DC Power Connections

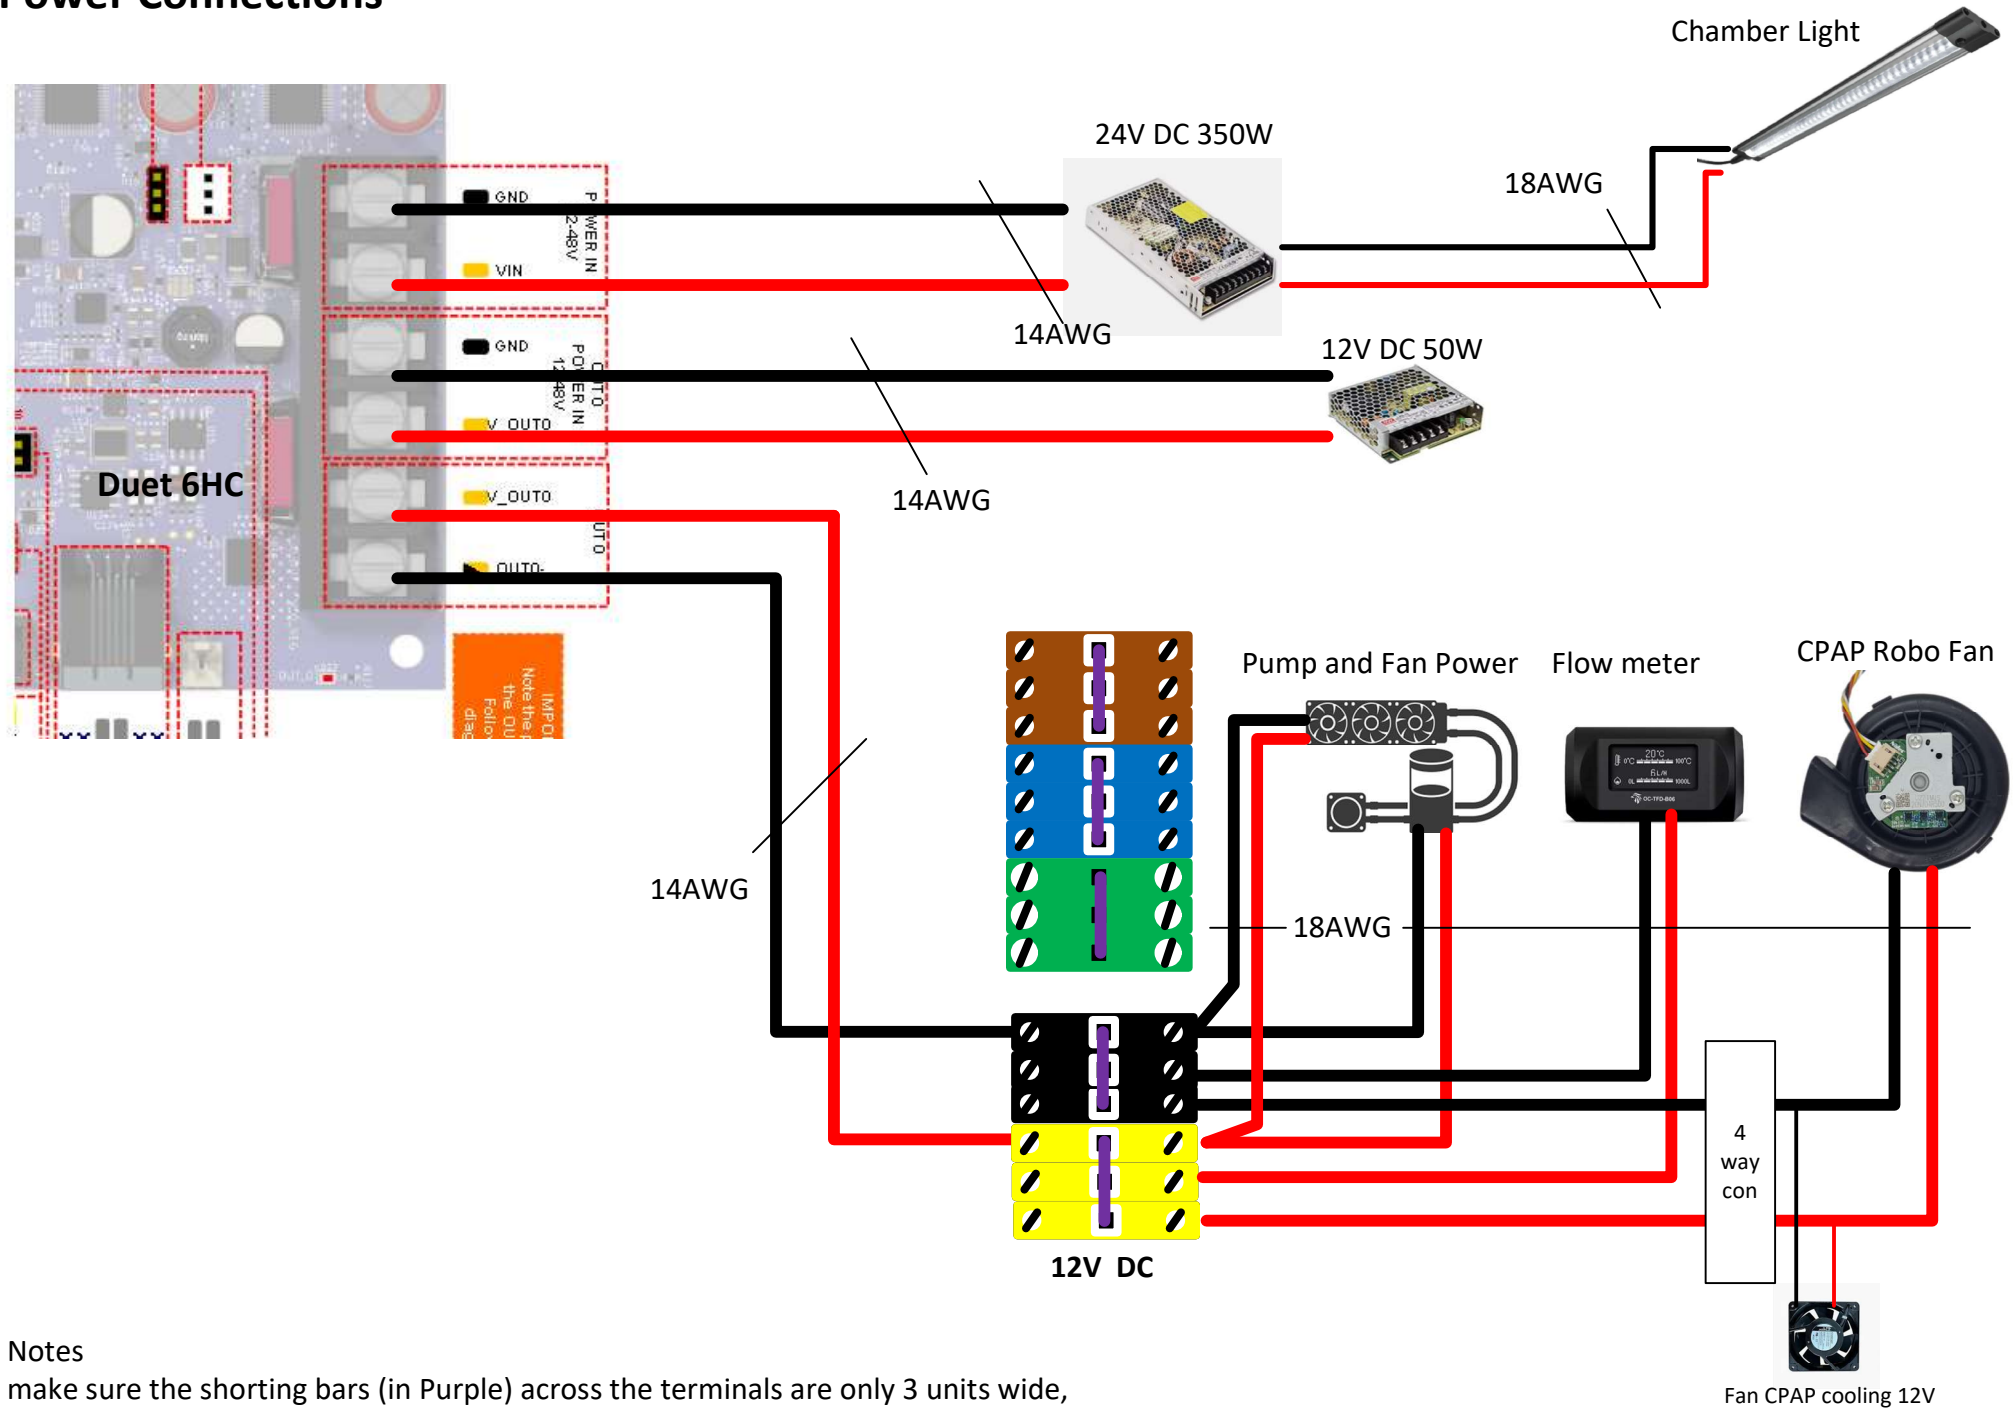
make sure the shorting bars (in Purple) across the terminals are only 3 units wide, and spacers inserted between each block of 3
